RYKER YAW Rate - SAS Sensor Faults - 137209

YAW rate sensor faults might be triggered due to loose front suspension components.

- Kit Parts List:

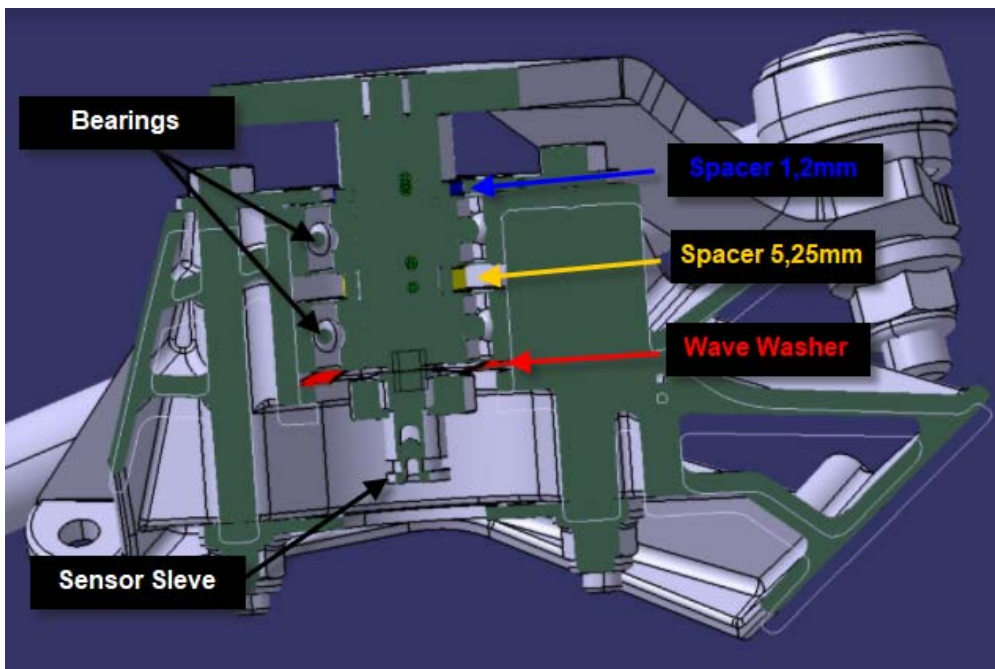
- If monitoring ID18 is there, replace the following;

Order kit P/N 219800513 (Note that this kit P/N is already installed from production on MY22 & up units)

- 1x 219800512 - Spacer 1.2 mm
- 1x 219800511 - Spacer 5.25 mm
- 2x 709402450 - Bearing
- 1x 219800510 - Wave washer
- 1x 709401526 - Sensor Sleeve
- 1x 487802246 - Generic Sheet

- Once parts are replaced, lock the steering system on the LH pitman arm and do a SAS reset with BUDS2. Use Alignment screw (P/N 529 036 490)

SAS Bushing;

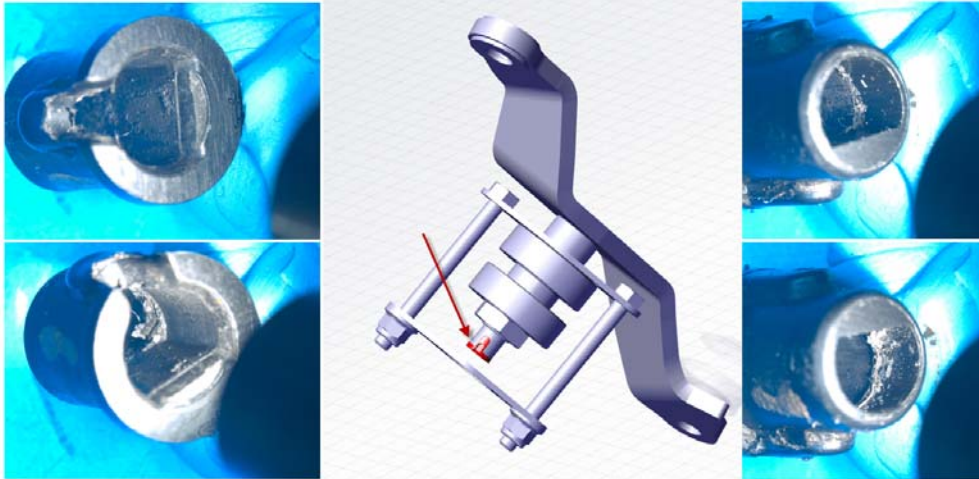
- A good sign that the steering components are too loose is that the SAS plastic bushing will be worn out by the excess of axial movements. The bushing is a tight fit on the SAS shaft. It needs to be replaced if you can easily remove it with your fingers. Here are some examples;
